Access Compliance Report

Public Rights-of-Way

(Curb Ramps)

Intersection ID: 16182	Main Street: MONROE_RD	Cross Street: SHADE VALLEY_RD	Location: NW
ADA ID: 5ED3F2F70BB6	Ramp Type: Directional1	Initial Pass/Fail: Fail	Overall Compliance: No
Severity Score: 13.75			
Codes/Mitigation Info/Possible Solution		Field Measurements/Component Compliance

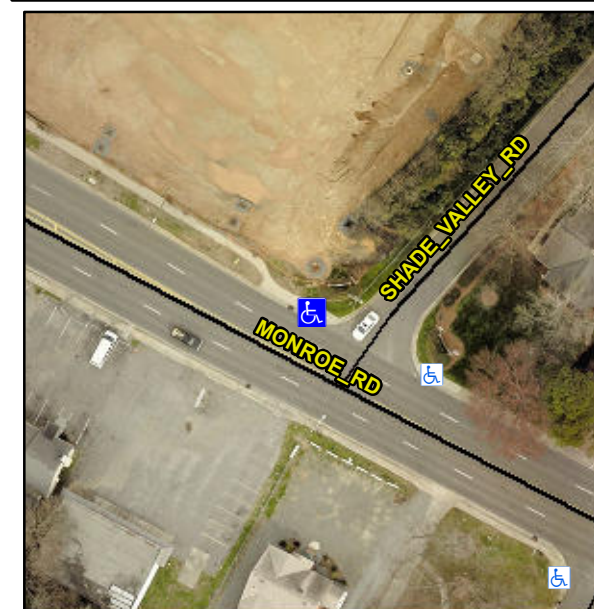
R304.2.2, R304.5.3

Compliance	Description	Data	Compliance	Description	Data
N/A	Ramp Length (in)	54.5	N/A	Grade Break?	N/A
Yes	Ramp Width (in)	63.0	N/A	Grade Break Slope (%)	0.0
No	Ramp Slope (%)	8.4	N/A	Grade Break XSlope (%)	0.0
No	Ramp XSlope (%)	2.8			
N/A	Flare Type LT	N/A	N/A	Flare Type RT	N/A
N/A	Flare Slope LT (%)	N/A	N/A	Flare Slope RT (%)	0.0
N/A	Flare Traversable LT?	N/A	N/A	Flare Traversable RT?	N/A
N/A	Landing Length (in)	0.0	N/A	DWS Provided?	N/A
N/A	Landing Width (in)	0.0	N/A	DWS Contrast?	N/A
N/A	Landing Slope (%)	0.0	N/A	DWS Length (in)	N/A
N/A	Landing X Slope (%)	0.0	N/A	DWS Full Width?	N/A
N/A	Landing Curb? (Y/N)	N/A	N/A	DWS Offset LT (in)	N/A
N/A	Shared Landing?	N/A	N/A	DWS Offset RT (in)	N/A
N/A	Gutter Ponding?	0.0	N/A	Gutter Slope (%)	N/A
N/A	Gutter Lip Ht (in)	0.0	N/A	Gutter X Slope (%)	N/A
N/A	Painted X Walk1?	No		Road Slope (%)	0.9
	X Walk 1 Direction	To SE		Road X Slope (%)	4.2
	X Walk 1 Width (in)	N/A		Clear Space?	N/A

Remove & Replace Entire Ramp.
